RETAINING WALL AT INDIAN RD. INTERCH.
CITY OF SARNIA

GENERAL LAYOUT

- Functional Planning Study -
C.A.E. 402 - Bluewater
Bridge to King's Hwy. No. 7
Proposed Indian Rd. Interchange
District #1 (Chatham)

SUBJECT: W.P. 176-67-02, Bridge Site 14-289
Retaining Wall at Indian Road Interchange
Highway 402
District #1, Chatham

PROPOSED RETAINING WALL AT SOUTH-END OF STRUCTURE

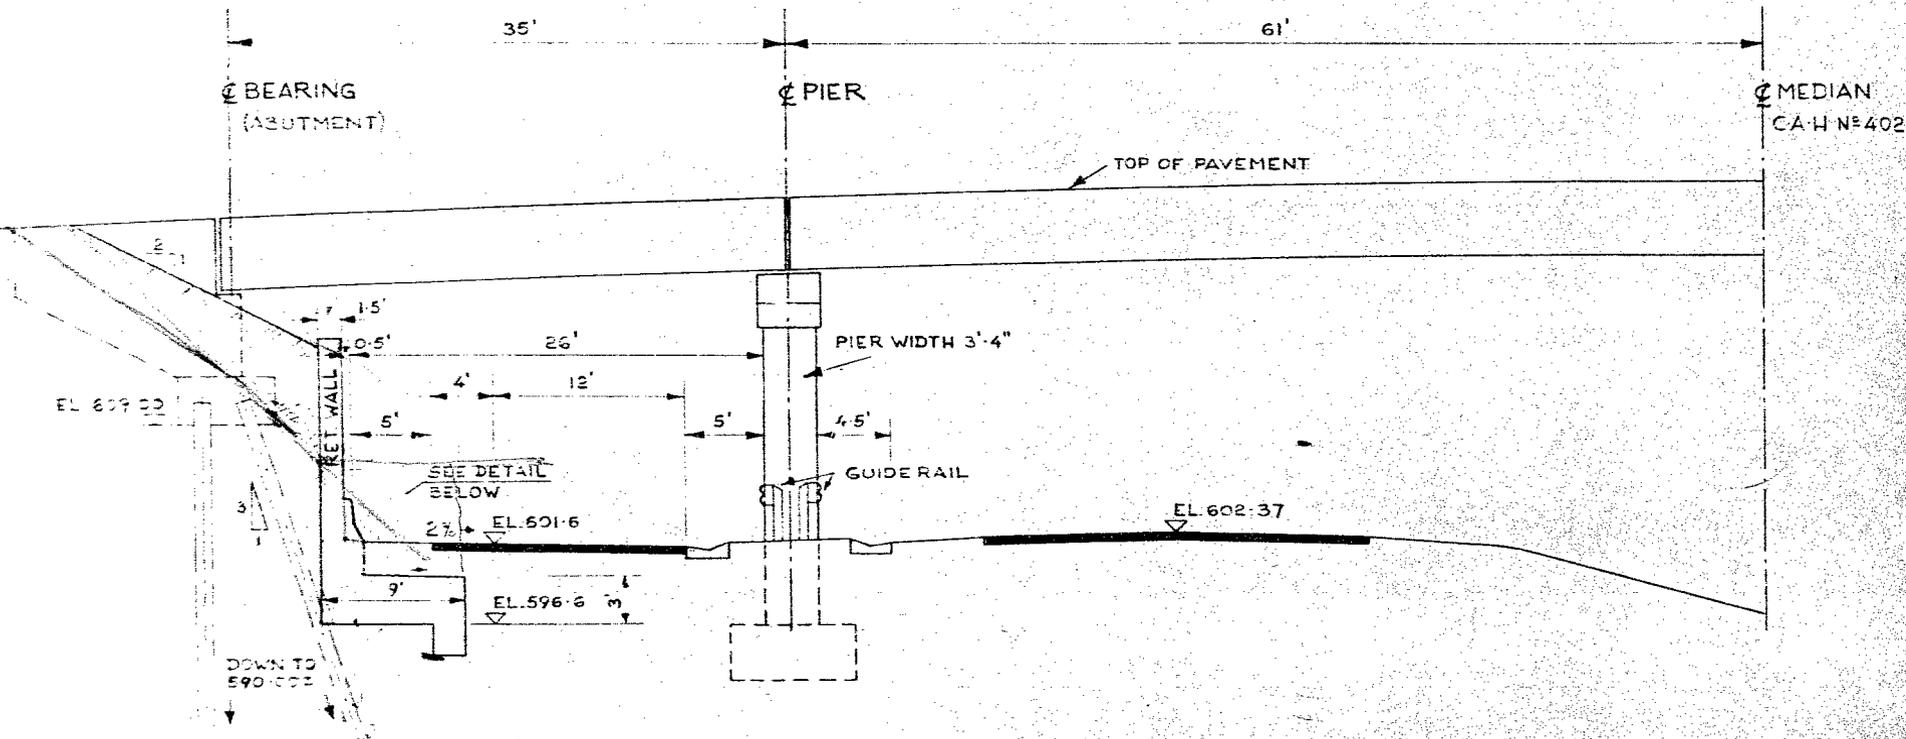
Further to our telephone conversation we enclose herewith for your review and comments one copy each of our Drawings 847-E-22 and 847-E-27.

Subject to acceptance of the horizontal clearance provisions shown on Drawing 847-E-27 we believe that it would be possible to obviate the need of reconstructing and adding on to the south half of the existing bridge by constructing an L shaped retaining wall in front of the south abutment.

The abutment piles are essentially end bearing and, therefore, the stability of the abutment will not be affected during the construction of the retaining wall. The cross-section of the wall as shown on the drawing is preliminary. However, we would recommend the treatment shown at shoulder level to ensure that a vehicle coming in contact with the wall is deflected back onto the pavement with minimum damage, if any.

PROPOSED RETAINING WALL AT SOUTH-END OF STRUCTURE

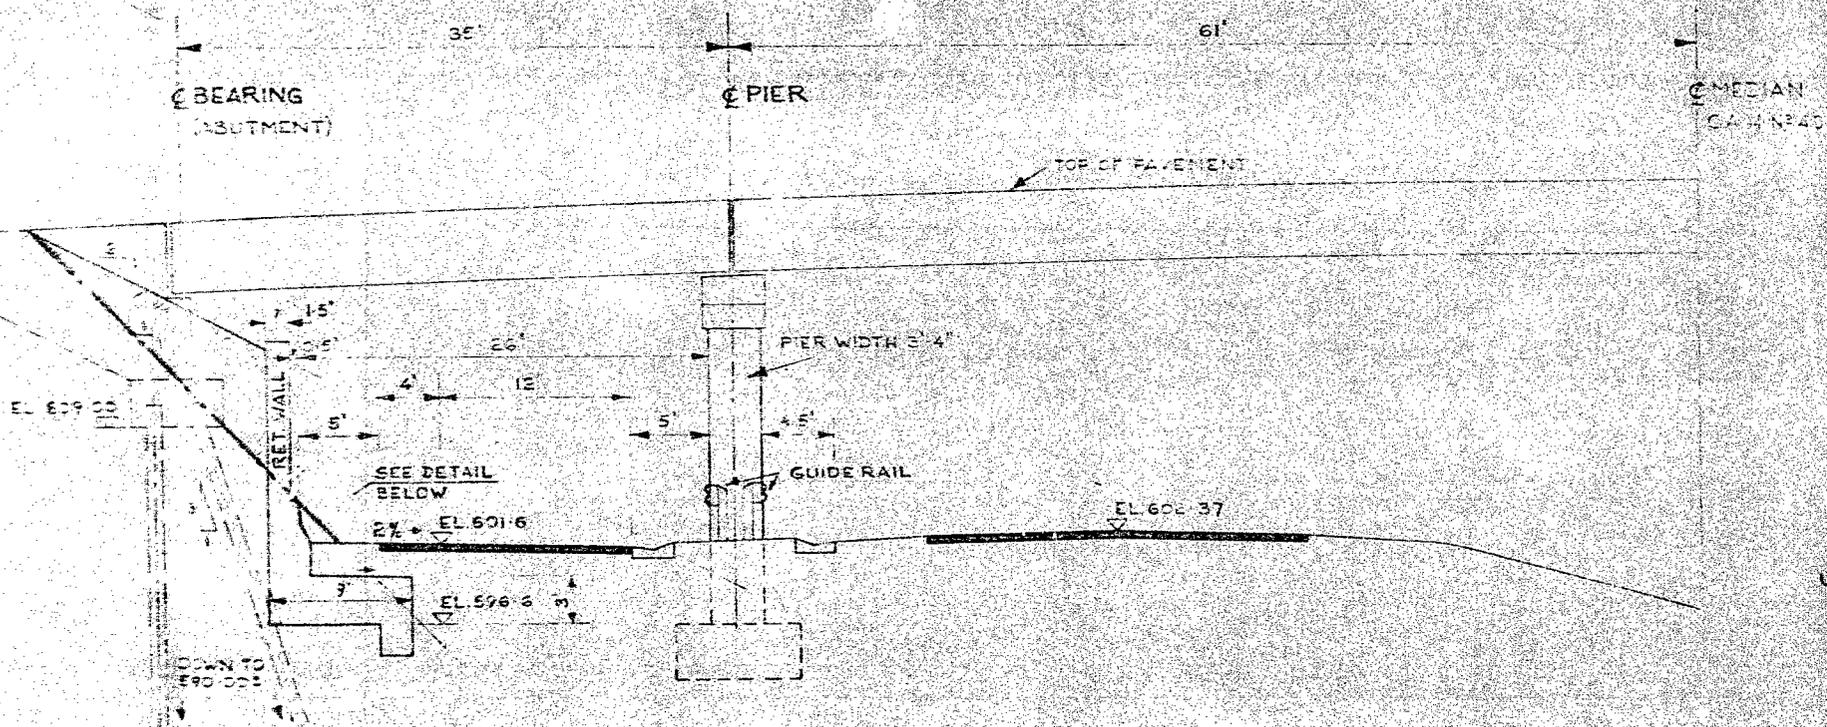
We have examined Drawings 847-E-22 and 847-E-27 prepared by your firm in connection with carrying the proposed ramp under the end span of the Indian Road Bridge, and wish to make the following comments:

In brief, Mr. Stermac cannot foresee any problems with the completed structure, however, construction of the proposed structure could create certain problems due to the close proximity of the piled abutment, and he recommends certain precautions to be taken when carrying out the construction of the retaining wall. The reader is referred to Mr. Stermac's memo for the details involved.

In connection with the above, the District has supplied us with the "as driven" pile tip elevations for the south abutment. The front row battered piles have a tip elevation of approximately 589.5, varying between 589.13 and 590.27. The rear row of vertical piles have a tip elevation averaging 589.39, varying between 588.7 and 591.4. Therefore the actual pile tip elevations agree fairly closely to the pile tip elevation of 590.00 as shown on the Drawing ~~847-E-27~~.

The elevation and cross-section shown on the upper right corner of Drawing ~~847-E-27~~ shows the cross-fall of the roadway as 2% down towards the pier. The roadway at this location is very close to the end of the horizontal curve for the ramp which would be superelevated in the opposite direction, and would therefore necessitate an abrupt reversal in the cross-fall to attain the 2% cross-fall shown in the vicinity of the structure.

We would prefer to eliminate the barrier curb profile which appears to be cast integral with the front face of the retaining wall. We feel that the front face of the retaining wall should be a flat surface to simplify forming, thus lending itself to simpler construction. Also the ramp would likely have guiderail at the edge of both shoulders and the guiderail could be continuous under the structure. This would eliminate any problem of transitioning the guiderail to the concrete barrier profile at the end of the retaining walls.
